ADDENDUM No. 02
September 12, 2016

AW Stanley Park and Aquatic Facility Improvements

New Britain, Connecticut
City of New Britain Bid Number 3896

The following changes and/or clarifications are hereby made to the Contract Documents dated August 22, 2016 for the above captioned project.

SU-1
SITE UTILITY PLAN

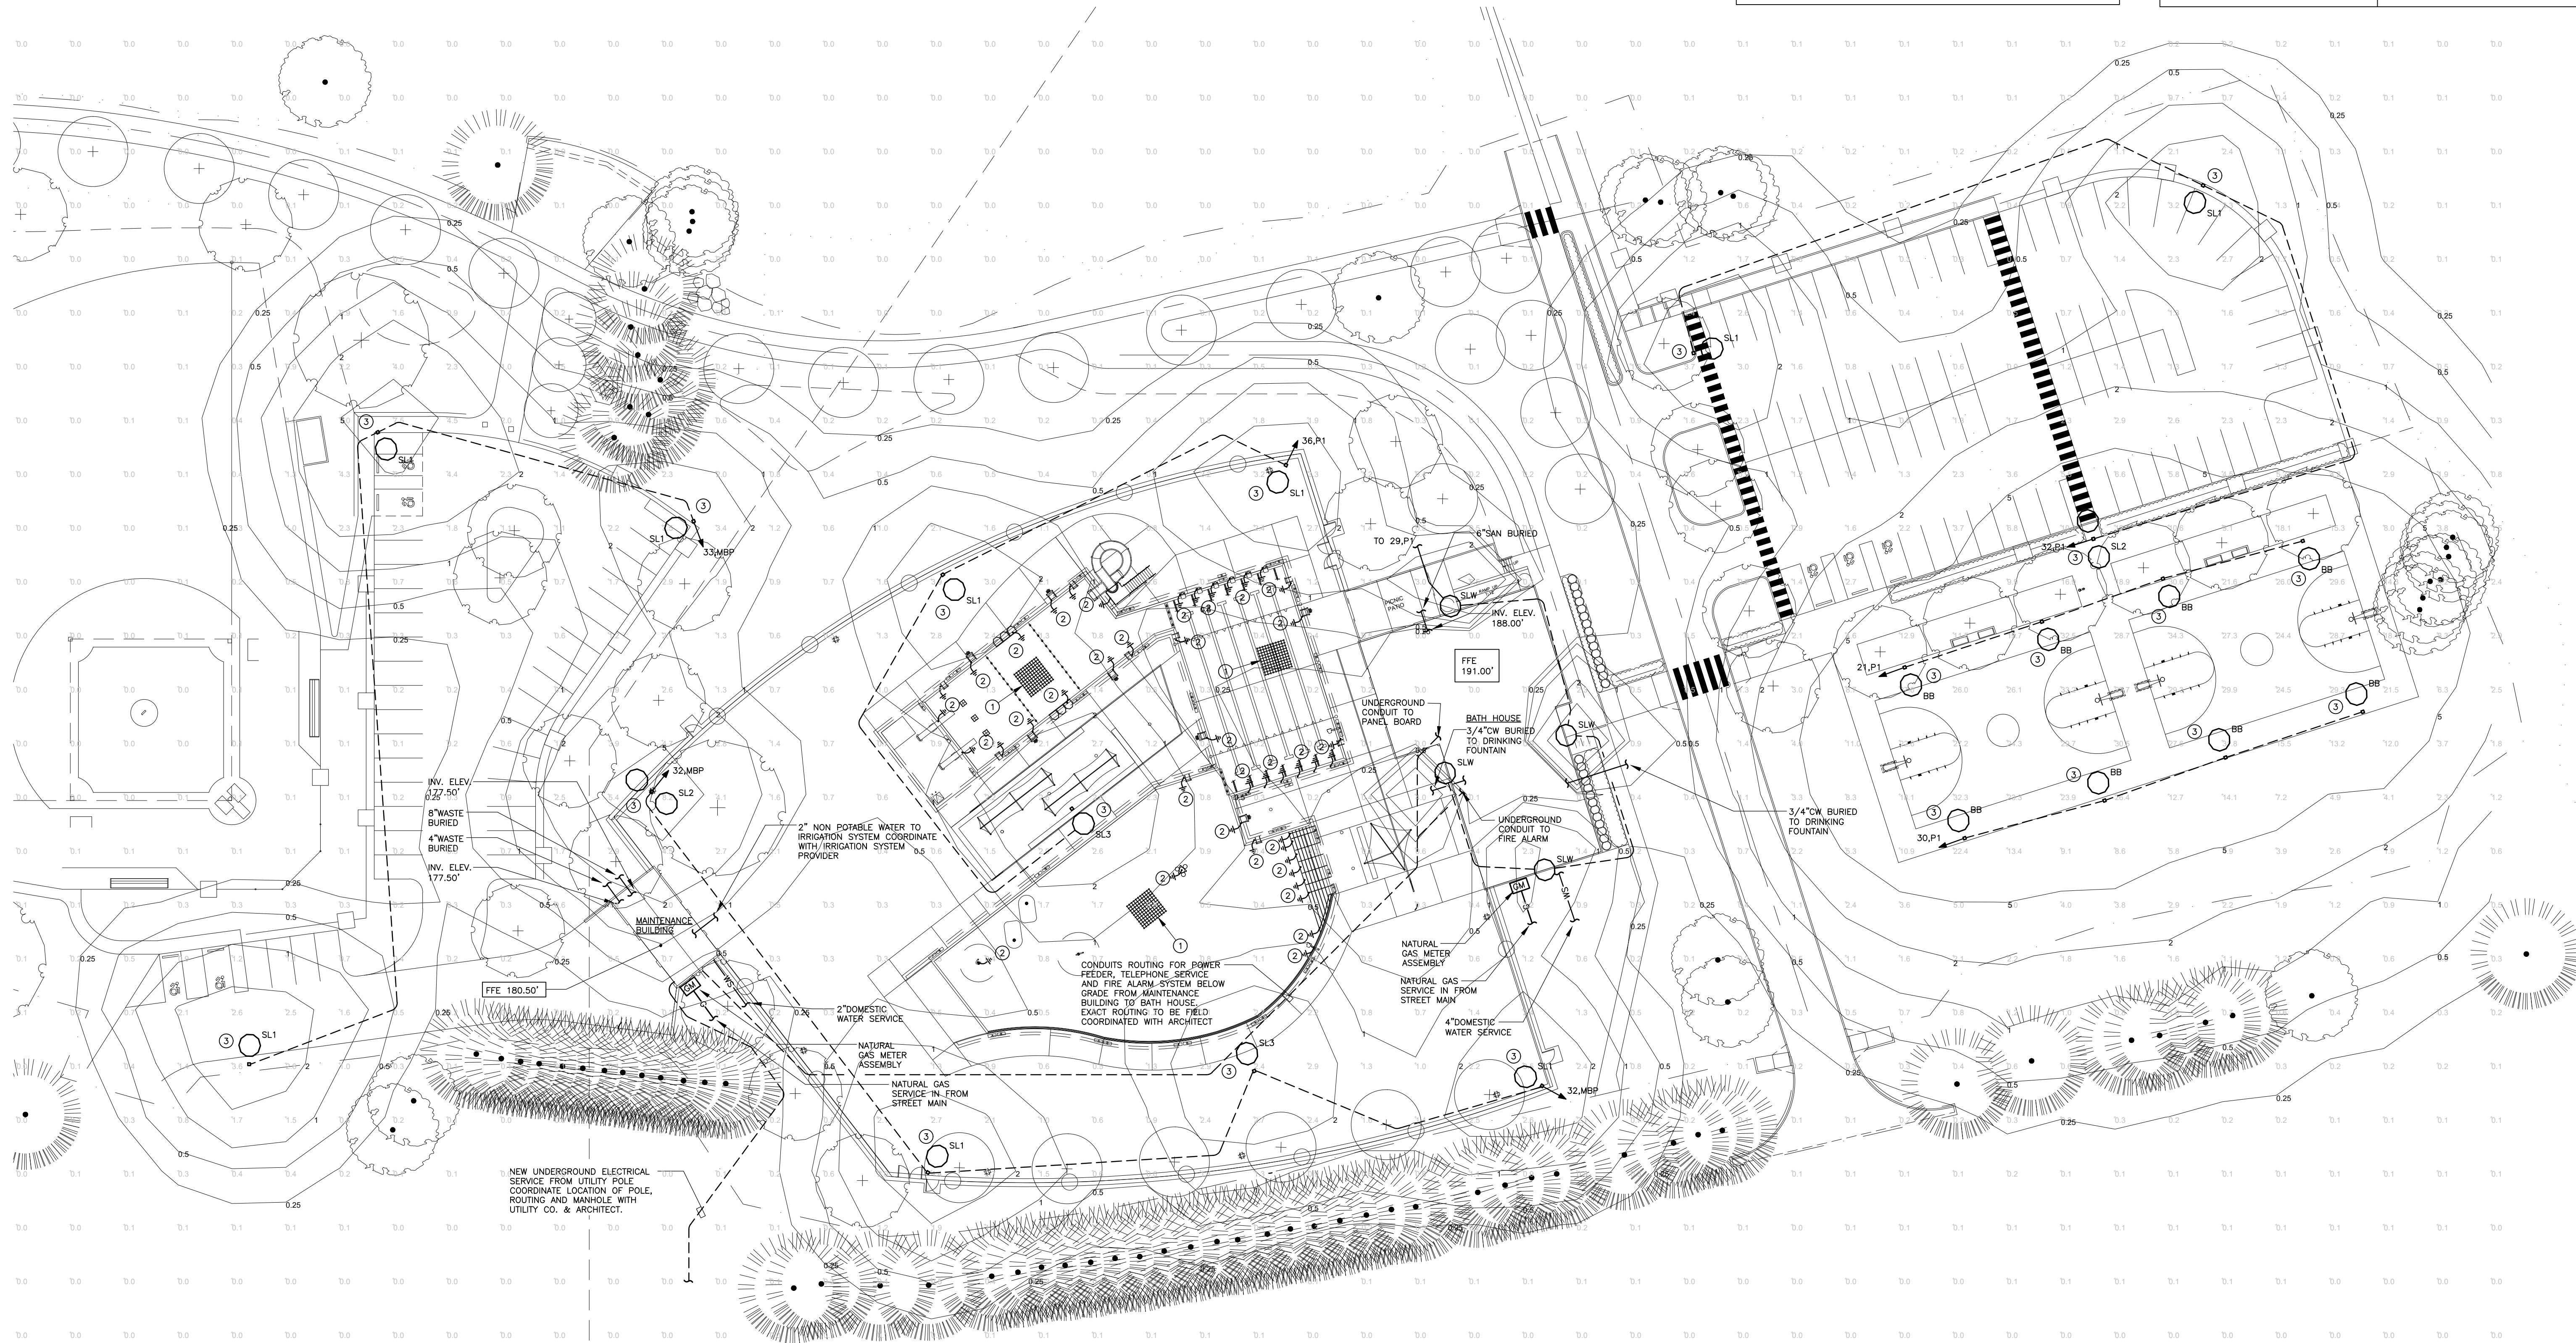
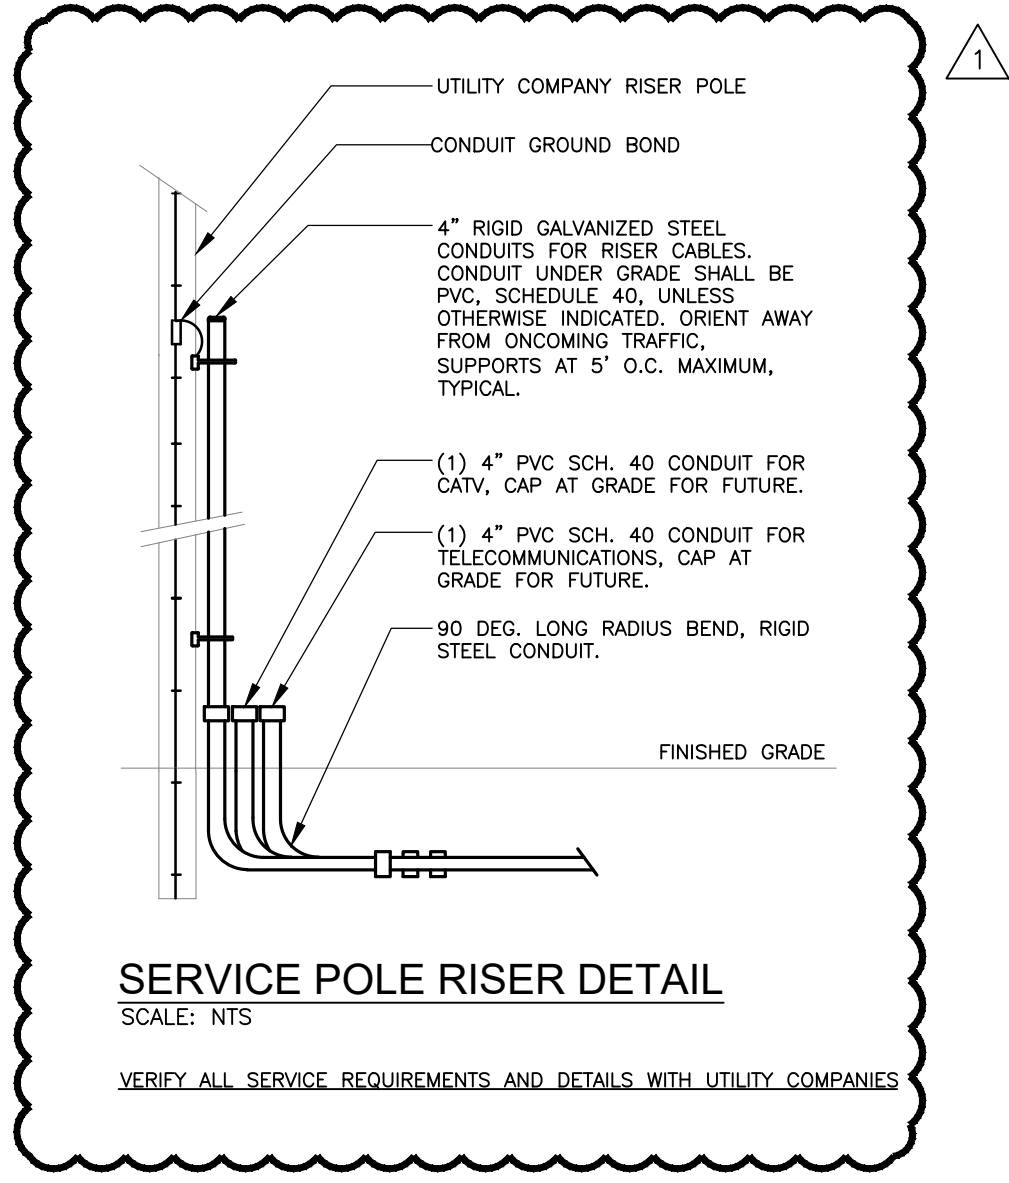
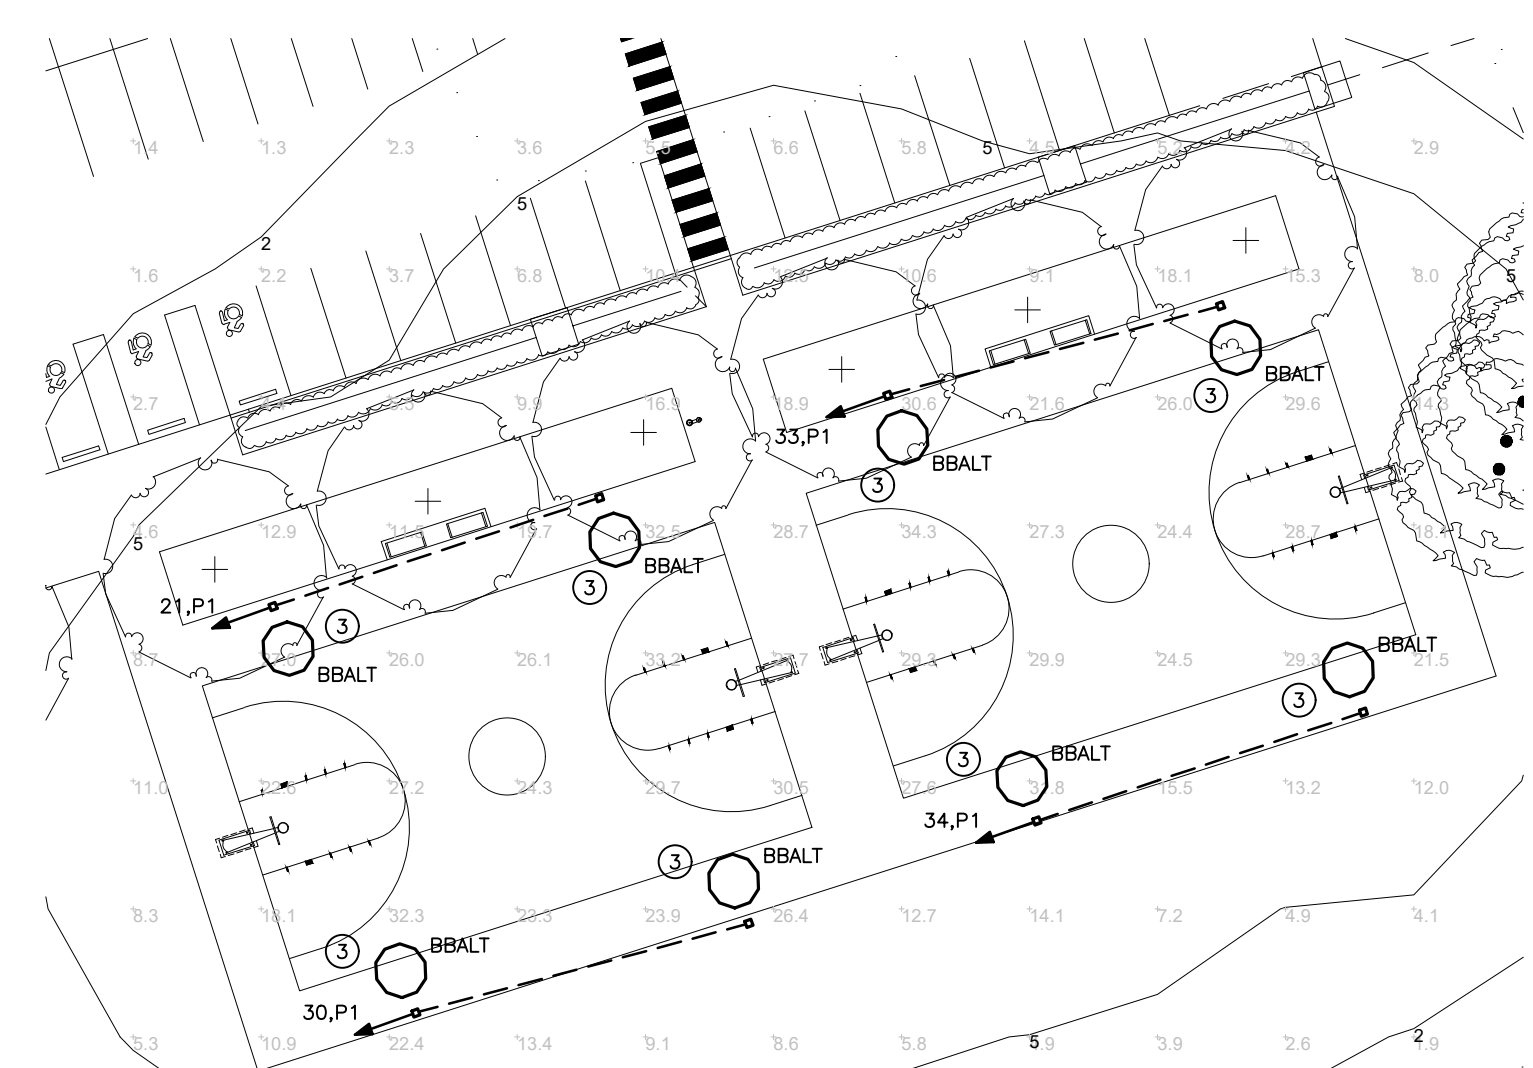
- a) Add: Drawing E-4, dated 9/12/16, in its entirety.
- 10) **Drawing S-1, Site Utility Plan**
- a) Delete Drawing SU-1, dated 8/22/16.
 - b) Add Drawing SU-1, R1, dated 9/12/16.
